# UNITED STATES PATENT AND TRADEMARK OFFICE

10/780,192

<b>Office Action Summary</b>	<b>Application No.</b> 10/780,192	<b>Applicant(s)</b> BROCHU ET AL.	
	<b>Examiner</b> Chi Q. Nguyen	<b>Art Unit</b> 3635

FIG. 1.

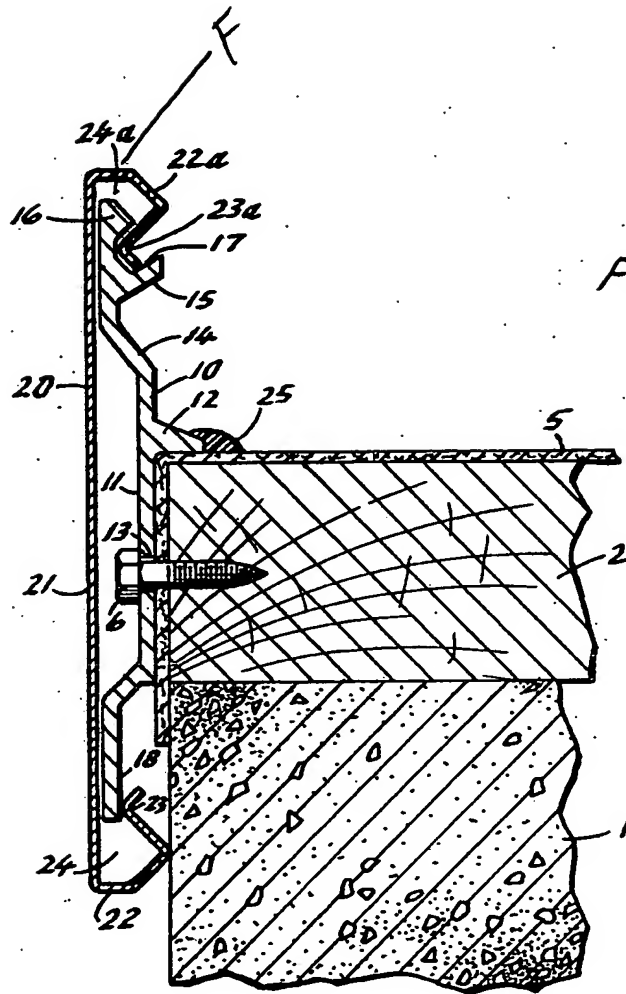
In regard claim 1, Butzen teaches a fascia system comprising a first member 20 and a second member 10, said first member 20 having an upper section, a drip edge

22a formed at an extremity of said upper section, a second lower section (where 21 points to) which includes a generally vertical extending portion 21 having first cooperative locking means 24 associated therewith, said second member 10 comprising a fascia member 1 having second cooperating locking means 17 at an upper portion (where 16 points to), the first cooperative locking means 24 hold said fascia member 1 in position, said second member 10 having a generally planar central portion 11, and an inwardly extending flange 18 arrangement at a bottom end of said generally planar portion 11 (see Fig. 1).

In regard claim 2, wherein said upper section of the first member 20 having a first portion F (see attachment of Fig. 1) and a second portion 22a angled downwardly with respect to the first portion F.
